730030 Modification to adapt for vDrive

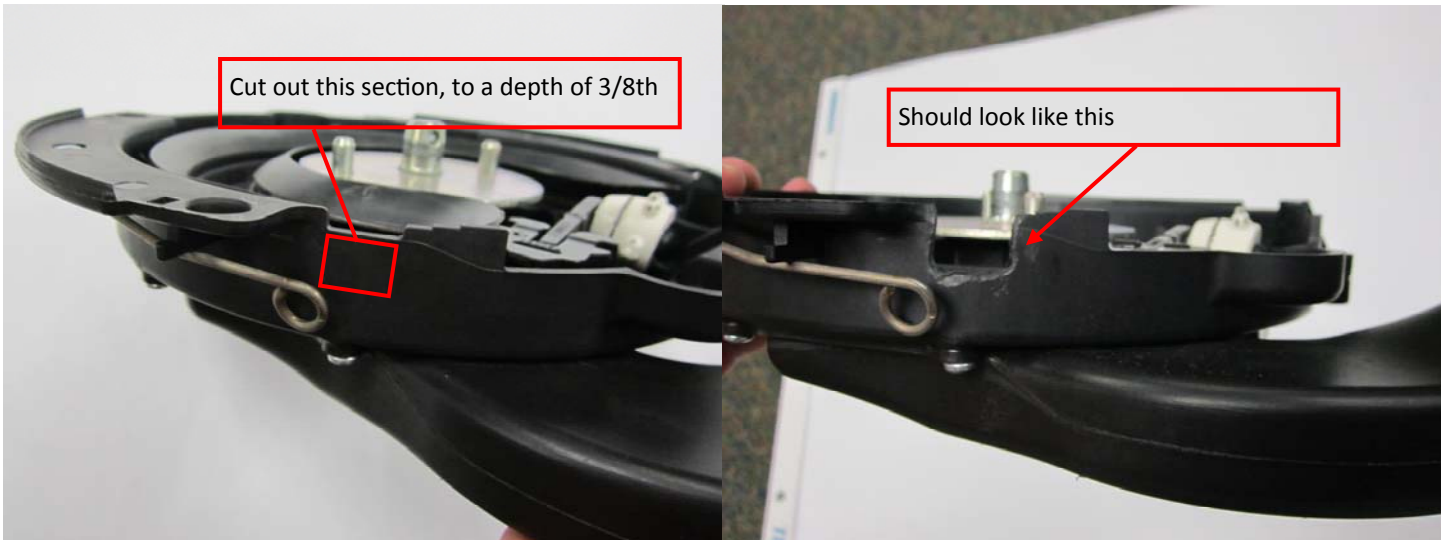
You will need to make two modifications to the housing to be compatible with vDrive. This is to keep seed fragments from interfering with the drive system.

1. Cut down $\frac{3}{8}$ th on each side. Then you should be able to take a pair of pliers and break the tab off. Clean all the filings off the cut.

2. You will need to drill a $\frac{1}{4}$ in hole into the side of the housing where the singulator slot. Make sure to clean all the shavings out of the meter housing.

Notice the hole is in the singulator slot.
